COMPLIANCE SUBMISSION

| | PROJECT TITLE: ST EDMUNDS - PHASE 3 | DATE: APR'22 | DRAWN BY: DG-MS |
| | DRAWING TITLE: BLOCK 4 ELEVATIONS & SECTION | SCALE: 1:200 | REVISION: A |
| 1 Graffham Street, Dublin 8, D08 APF7, Ireland Tel: 01-4782700 Fax: 01-4782711 E-Mail: enq@mccorm.com | | JOB NO: 18025.2 | DRAWING NO: CP401 |

01 - EAST ELEVATION

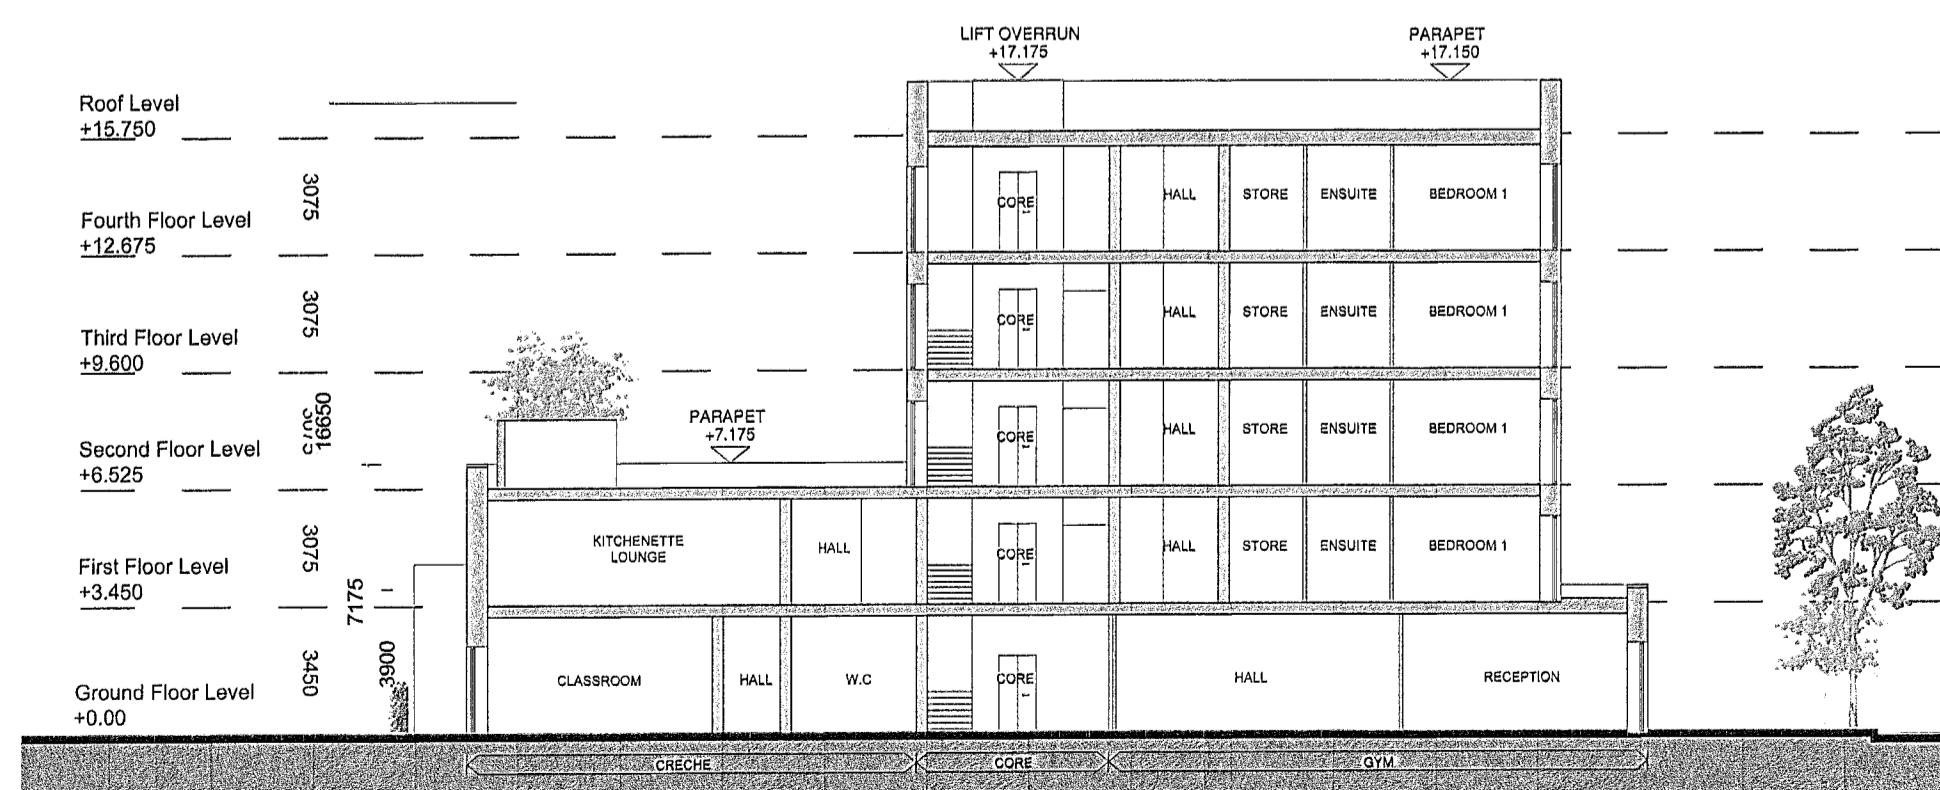
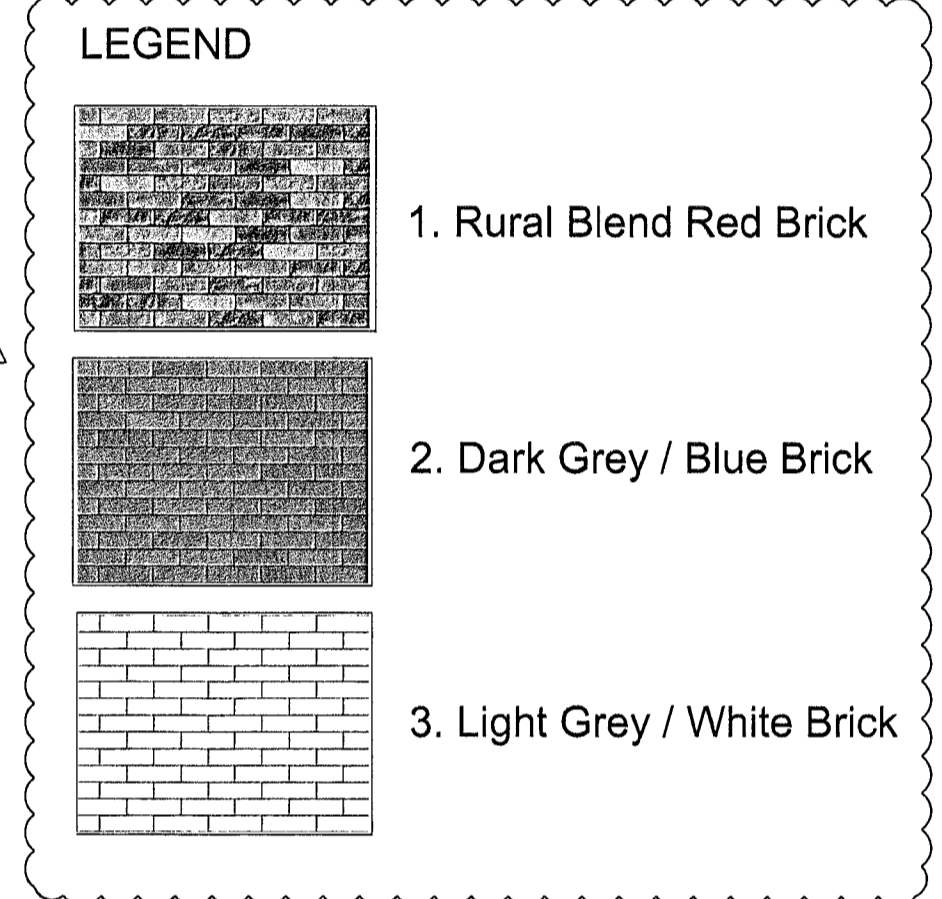
Render removed from material palette as per ABP conditions

| REVISIONS | | No. |
|-----------|--------------------------------------|-----|
| 10.02.23 | Clarification of Brick Type Finishes | A |
